COMMITTEE OF THE WHOLE MAY 29, 2006

SITE DEVELOPMENT FILE DA.06.022
ARCHDIOCESE OF TORONTO

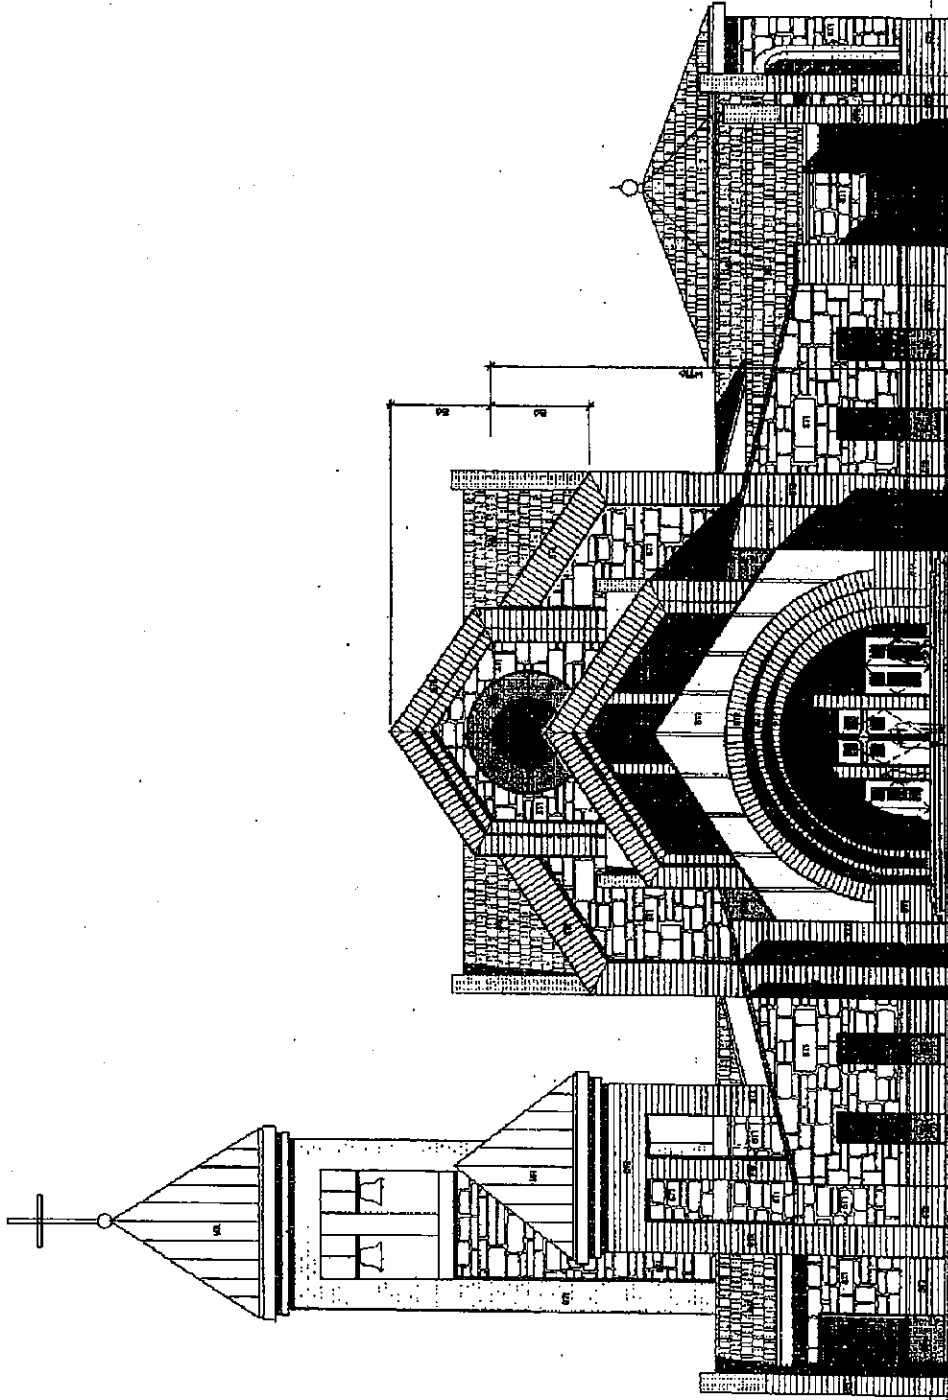
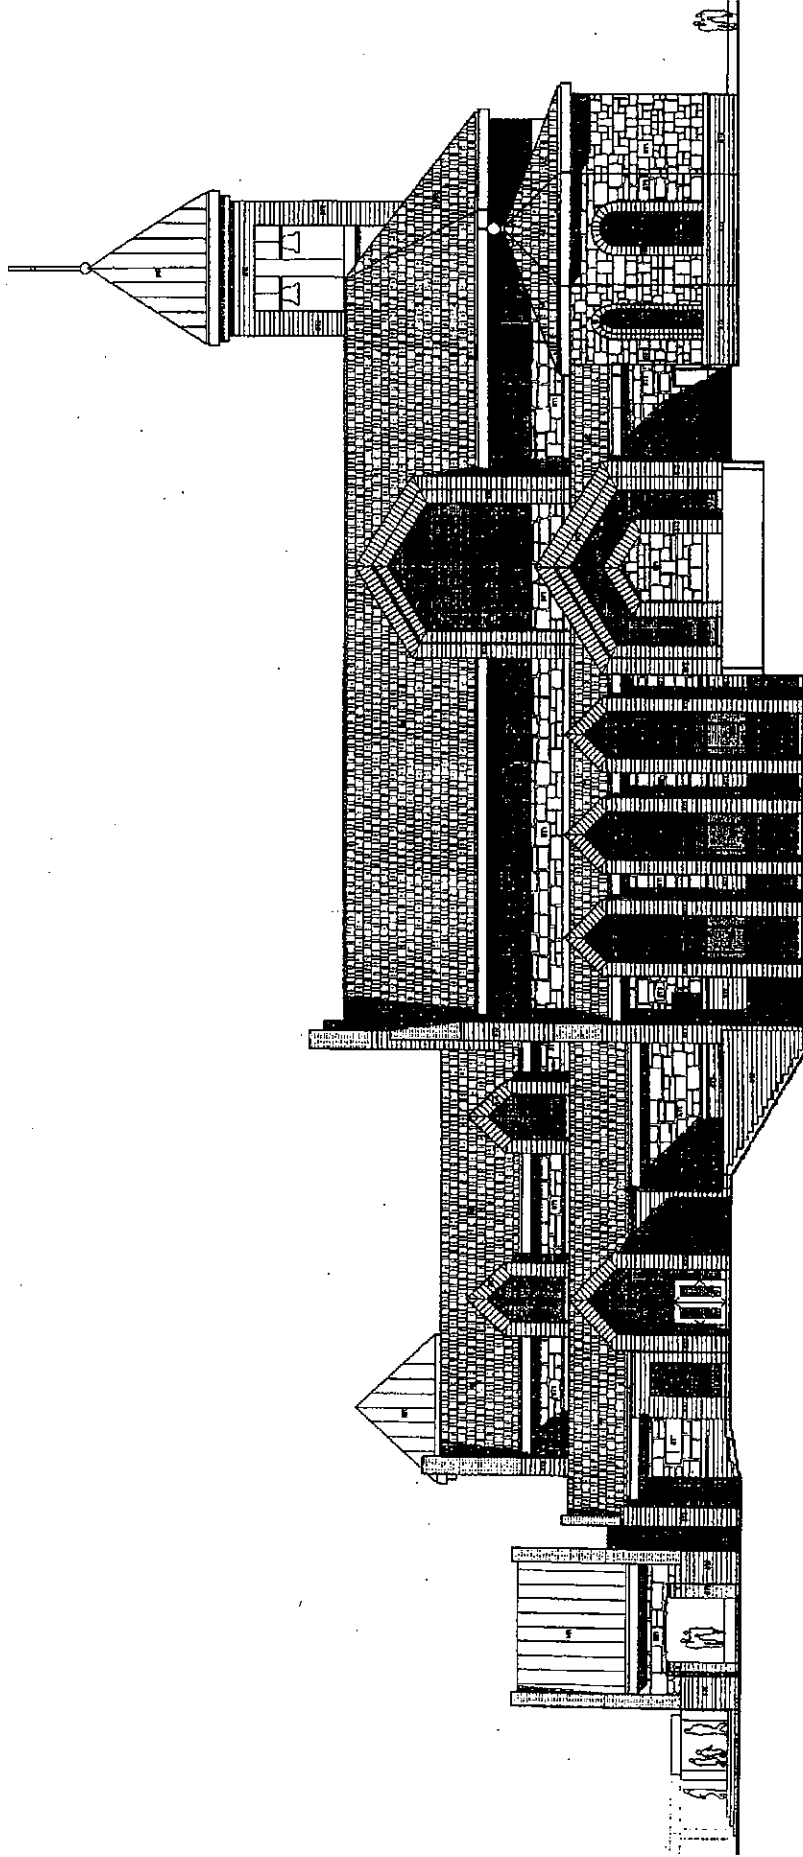
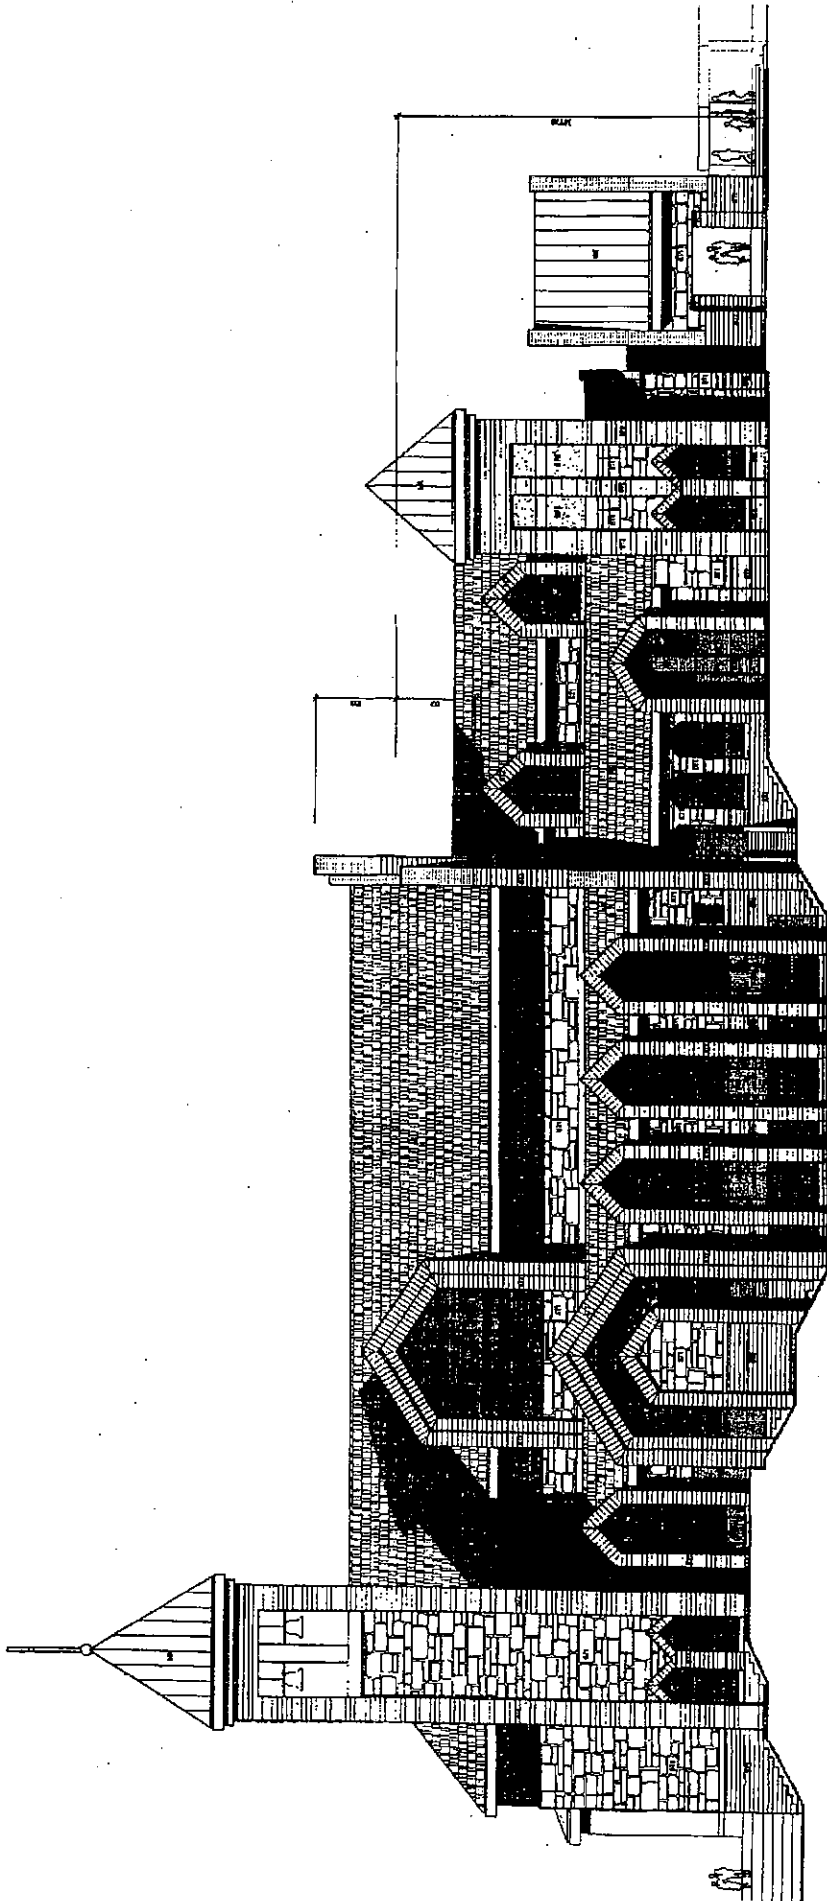
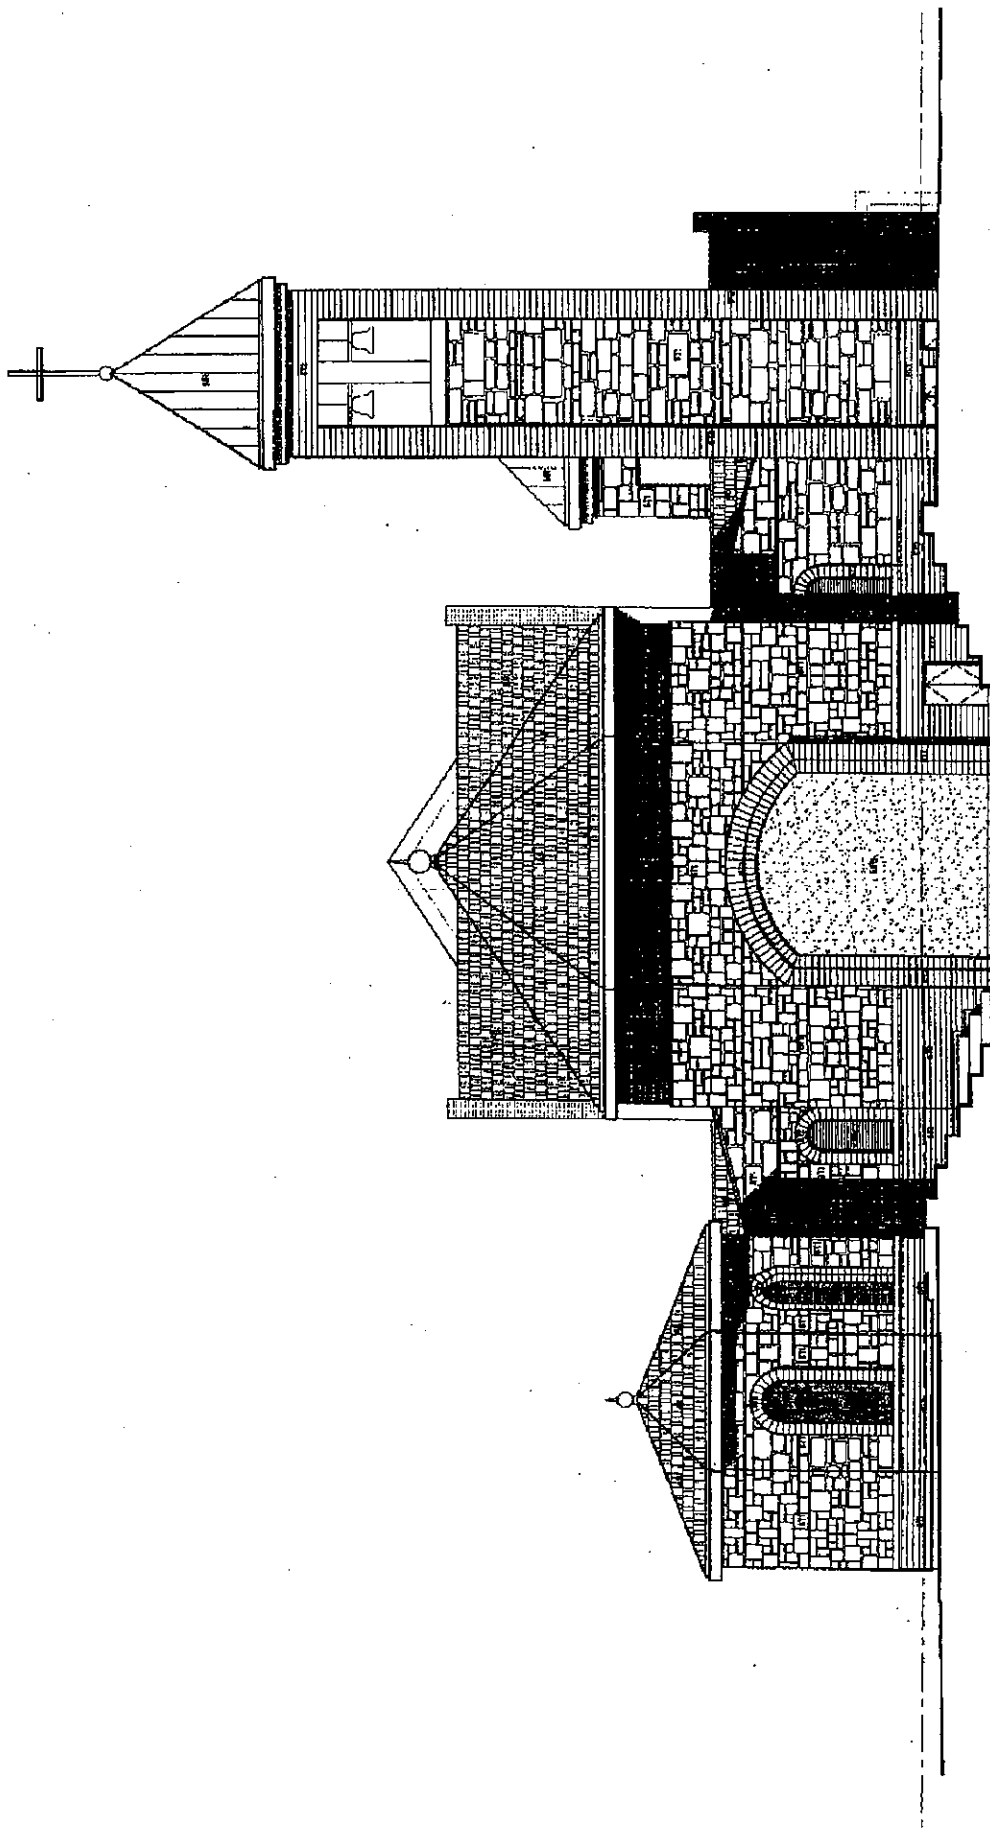
The proposed building elevations for the place of worship are shown on Attachments #4, #5, #6 and #7. The one-storey building will be constructed to a maximum height of 14.8m, with different level gable-roof tops throughout. The building material proposed consists of beige-tone manufactured stone, renaissance stone and limestone. The building incorporates many architectural details on the building facades, windows and along the roof-lines. A bell tower is located at the southwest corner, with a brown-tone metal roof. The main entrance consists of a gable-roof atrium (Phase 3) with stained and tinted glass. The side elevations (north and south) feature a series of prominent glass and stained glass windows that help define the architecture of the structure.

The building has been designed to address the grade of the site. The central portion of the building drops below the main grade of the site and allows for the provision of the prominent windows. The rear elevation (west) of the building has been designed to be primarily functional and is consistent with the balance of the structure. The west elevation is visible from the parking area and is adjacent to the proposed amphitheatre (Phase 3), however, provides sufficient architectural elements to define the structure and to display the strong lines of the entire building.

The final building elevations must be approved to the satisfaction of the Development Planning Department.
